Access Compliance Report Public Rights-of-Way (Curb Ramps)

Main Street: O_NEILL_DR Cross Street: ETON_PL Location: SW

ADA ID: RPRK211027120334 Ramp Type: Type 6 - Directional 1 Initial Pass/Fail: Fail Overall Compliance: No Severity Score: 15

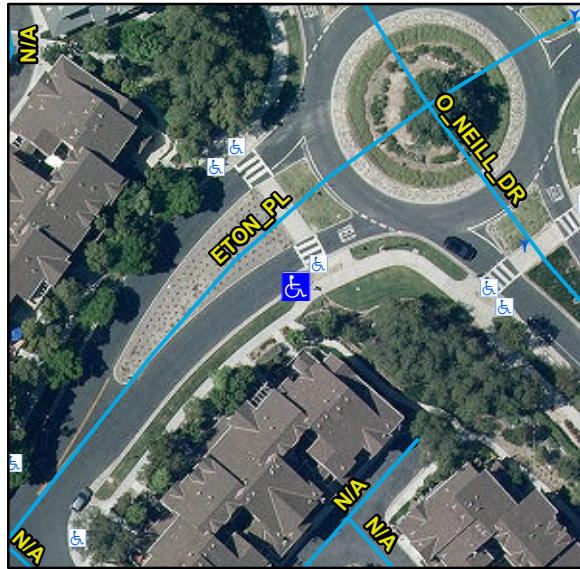
Compliance	Description	Data	Compliance	Description	Data
N/A	Ramp Length (in)	71	N/A	Flare Type LT	
Yes	Ramp Width (in)	70			N/A
No	Ramp Run Slope (%)	11.1	N/A	Flare Slope LT (%)	N/A
Yes	Ramp Cross Slope (%)	1.2	N/A	Flare Traversable LT	N/A
N/A	Grade Break	N/A	N/A	Flare Type RT	
N/A	Grade Break Slope (%)	N/A			N/A
N/A	Grade Break Cross Slope (%)	N/A	N/A	Flare Slope RT (%)	N/A
	Addl Para Ramp Left?	No	N/A	Flare Traversable RT	N/A
	Addl Para Ramp Right?	No	N/A	DWS Provided	N/A
N/A	Landing Present	N/A	N/A	DWS Contrast	N/A
N/A	Landing Length (in)	N/A	N/A	DWS Length (in)	N/A
N/A	Landing Width (in)	N/A	N/A	DWS Full Width	N/A
N/A	Landing Run Slope (%)	N/A		DWS Offset Type	N/A
N/A	Landing Cross Slope (%)	N/A	N/A	DWS Left Offset (in)	N/A
N/A	Landing Movement Obstructed?	N/A	N/A	DWS Right Offset (in)	N/A
	Landing Movement Type	N/A			
N/A	Landing Shared	N/A			
N/A	Marked Crosswalk 1	No	N/A	Clear Space	N/A
	Crossing 1 Direction	W	N/A	Clear Space To Crosswalk (in)	N/A

Remove & Replace Entire Ramp.

R204.3, R304.2.2, STD 1115
